# Staff Report

**To:** Salt Lake City Planning Commission  
**From:** Diana Martinez, Senior Planner, [diana.martinez@slcgov.com](mailto:diana.martinez@slcgov.com), 801-535-7215  
**Date:** March 27, 2024  
**Re:** PLNPCM2023-00610- Design Review application

## Design Review

**PROPERTY ADDRESS:** 1330 S. 700 W.  
**PARCEL ID:** 15-11-480-027-0000  
**MASTER PLAN:** [The Westside Master Plan](#)  
**ZONING DISTRICT:** [21A.26.030: CB COMMUNITY BUSINESS DISTRICT: \(amlegal.com\)](#)  
**OVERLAY DISTRICT:** [21A.34.030: T TRANSITIONAL OVERLAY DISTRICT: \(amlegal.com\)](#)

Sheet:  
**AS101**  
1 of 1

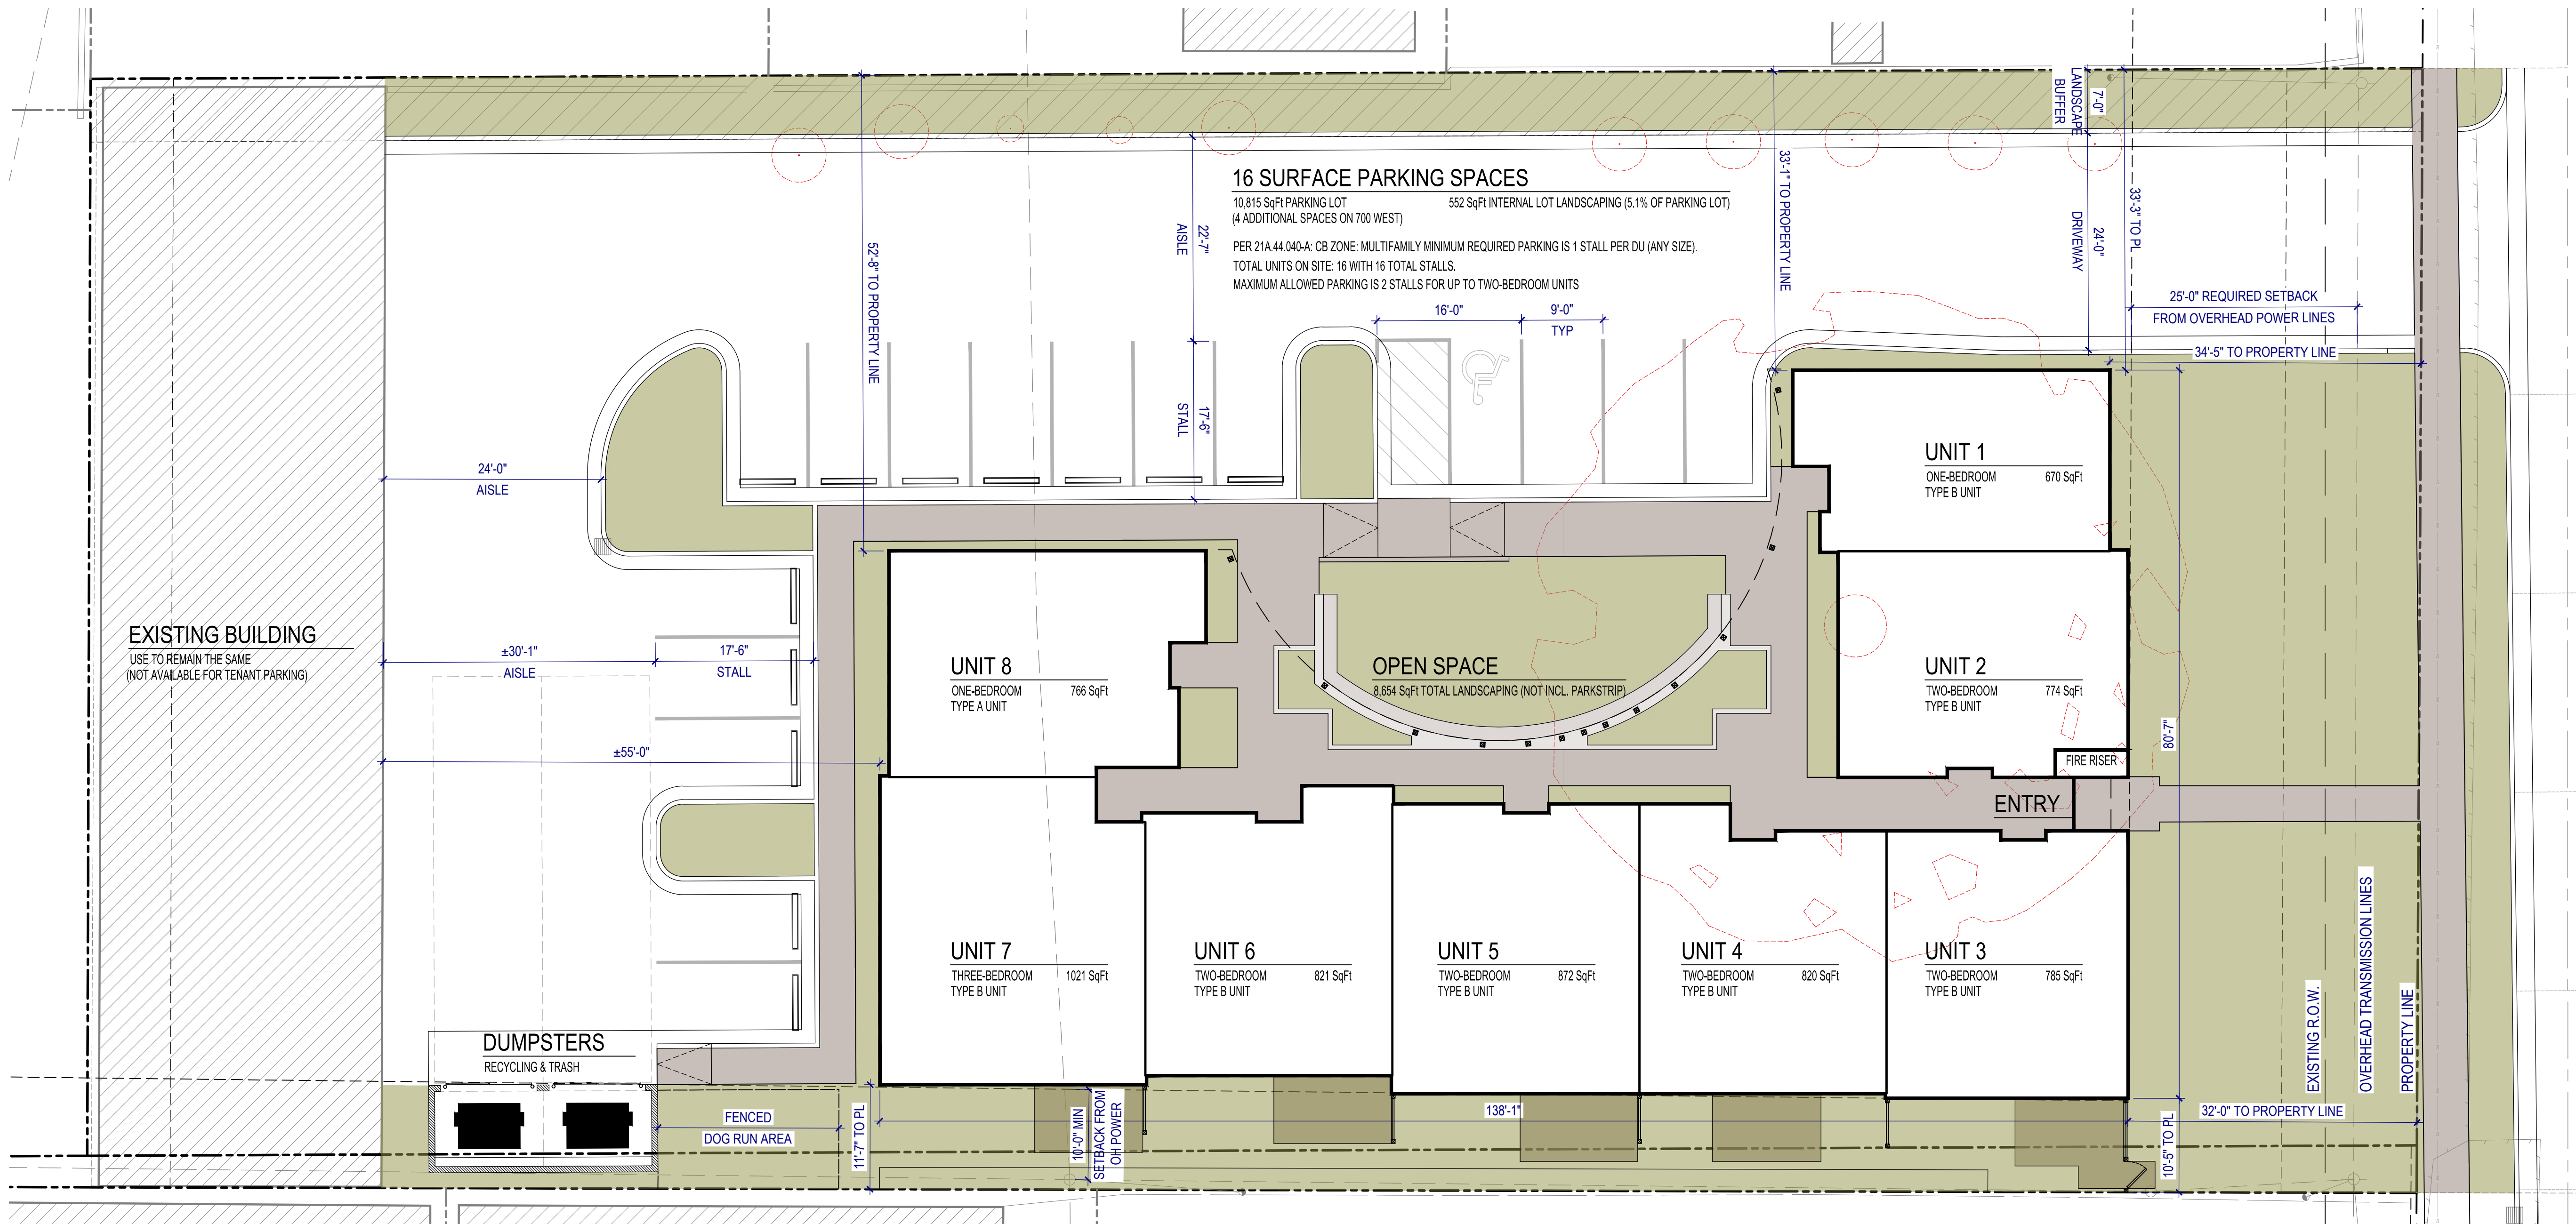
The applicant is required to go through the Design Review process since they are proposing a front yard setback of more than the 15 feet allowed maximum setback.

The applicant requests approval for the front yard setback to be approximately 32 feet. This is due to Rocky Mountain Power (RMP) 's requirement that new construction be 25 feet away from power poles. Since the power pole sits approximately 7 feet into the property, additional footage is needed to meet the requirements of RMP.

Having a 32' setback in the front yard will not negatively impact this area. Most of the properties along 700 West between 1300 South and 2100 South have buildings set back at least 25' or more. Since only the subject property and the property to the north are the only properties not zoned M-1 along this stretch of 700 West, the front yard setbacks for most of the building are quite compatible. Other properties along 700 West will be subjected to Rocky Mountain Power's front yard setback requirement if they redevelop since the power poles run along the west side of 700 West.

**Design Review:** Based on the information and findings listed in this report, staff recommends that the Planning Commission approve the design review petition PLNPCM2023-00610 with the following condition:

Street Facing Glass Calculations

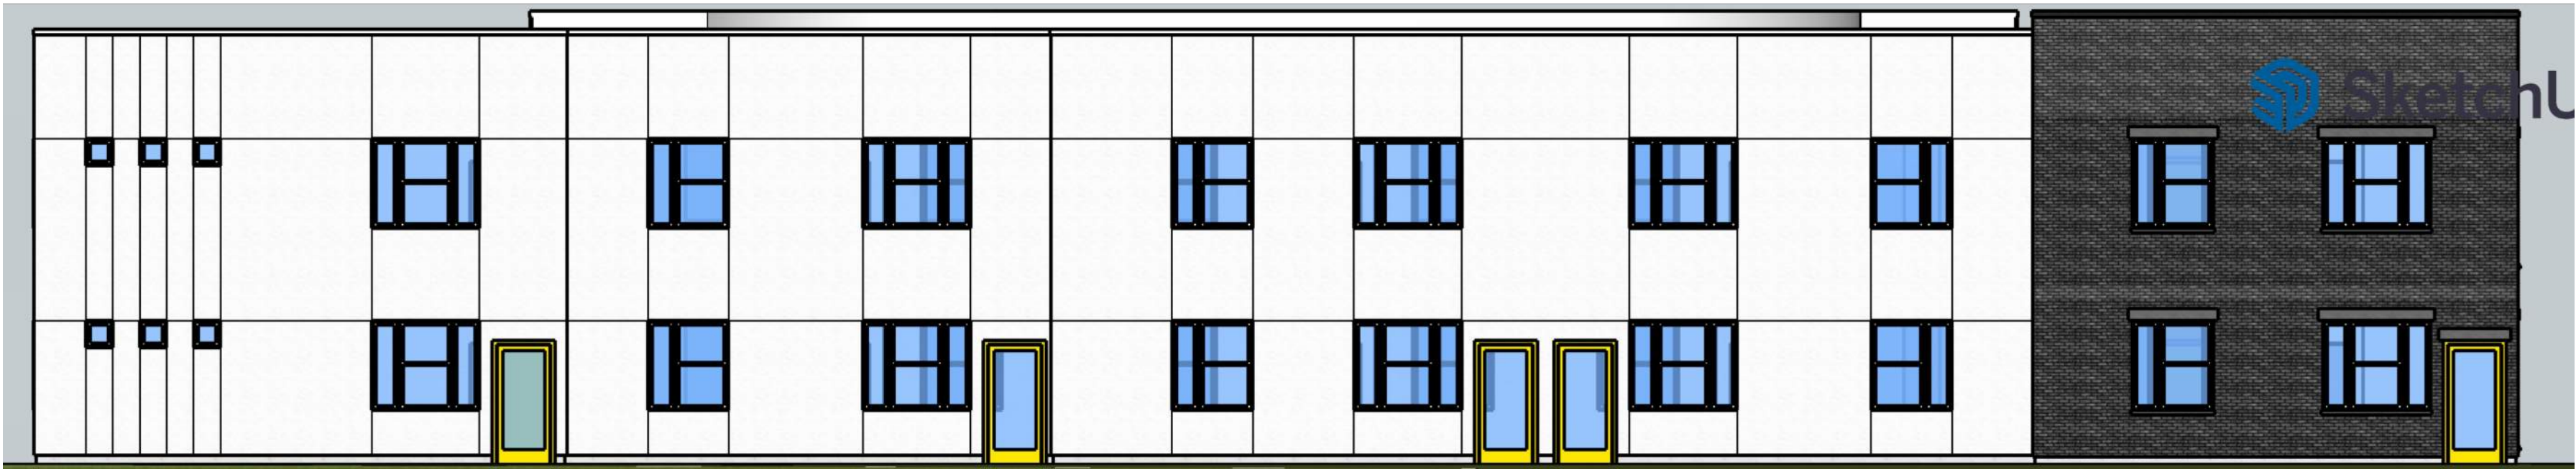
the form of a patio or plaza, subject to site plan review approval.		
<b>Signage (21A.46.110)</b>	Signage and wayfinding shall be integrated with the architecture of the parking structure and be architecturally compatible with the design.	A sign package will be required during the building permit process if applicable.	Complies
<b>Building Materials</b>	Durable materials include stone, brick, masonry, textured or patterned concrete, and fiber cement board or other material that includes a minimum manufacturer warranty of twenty (20) years from color fading, weather, and local climate induced degradation of the material.	The applicant is proposing White stucco, dark gray brick on the building and the windows will be in white vinyl.  *There is no building material percentage required in the CB zone.	Complies
<b>Ground Floor Glass</b>	40% - The ground level of the building is occupied by residential uses that face the street, in which case the specified minimum glass requirement may be reduced by fifteen percent (15%).	The proposal will provide 46% ground floor glass.	Complies
